Monitoring Report
FINAL VERSION
Horne Creek Tributaries Mitigation Project
Monitoring Year 4
Calendar Year of Data Collection: 2023

NCDEQ DMS Project Identification # 100026
NCDEQ DMS Contract # 7181
Yadkin River Basin (Cataloging Unit 03040101)
USACE Action ID Number: SAW-2017-01510
NCDEQ DWR Project # 2017-1156
Surry County, NC
Contracted Under RFP # 16-006993, Date of Issue: September 16, 2016
Data Collection Period: April and October 2023
Submission Date: November 2023

RE: WLS Responses to NCDEQ DMS Review Comments for Task 10 Submittal, Monitoring Year 4 Report for the Horne Creek Tributaries Mitigation Project, DMS Full-Delivery Project ID #100026, Contract #7181, Yadkin River Basin, Cataloging Unit 03040101, Surry County, NC

FIGURE
1c

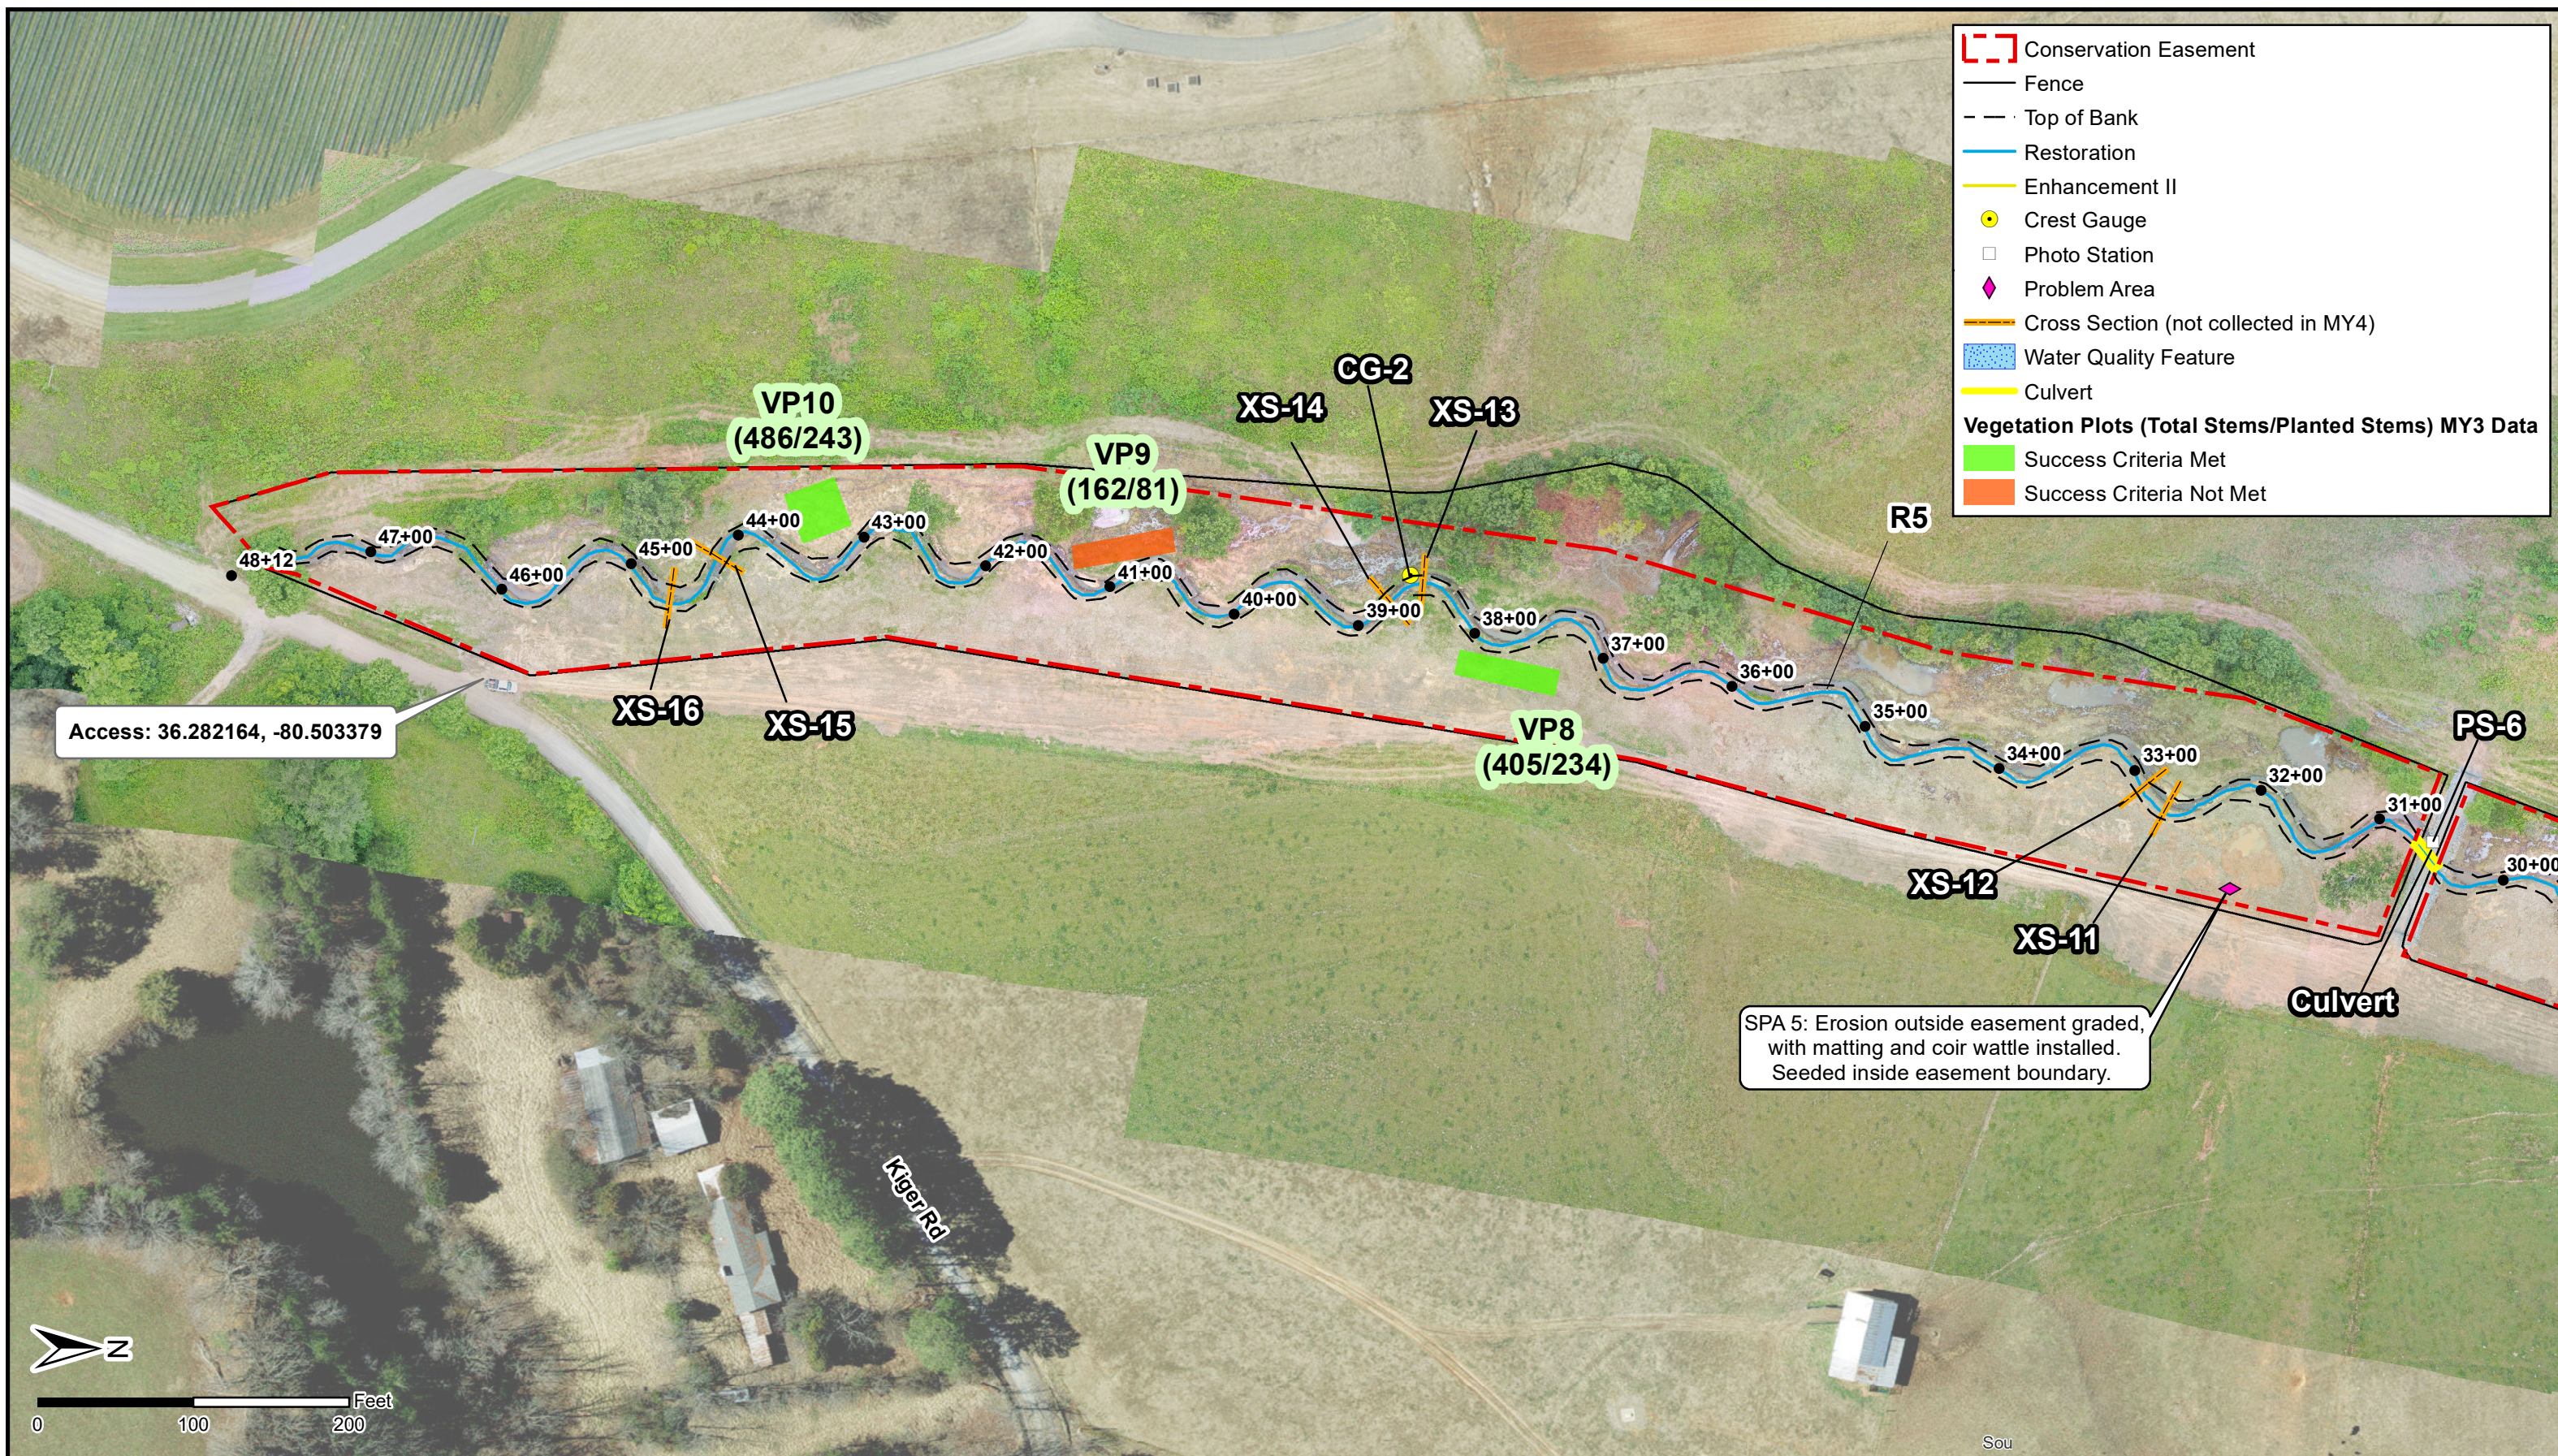
- **Title Page: RFP date of issue should be September 16, 2016.** WLS Response: The title page is updated as requested.
- **Table 2: Please add the SPA5 repair that occurred in 2023 to the table.** WLS Response: SPA5 repair has been added to Table 2 for MY4 (2023).

- **Thanks for including pictures of SPA5 repair. Please include update and photos in MY5 report.** WLS Response: WLS will include photos of SPA5 during MY5 to document stabilization of the repair area.

SPA 5: Erosion outside easement graded, with matting and coir wattle installed. Seeded inside easement boundary.
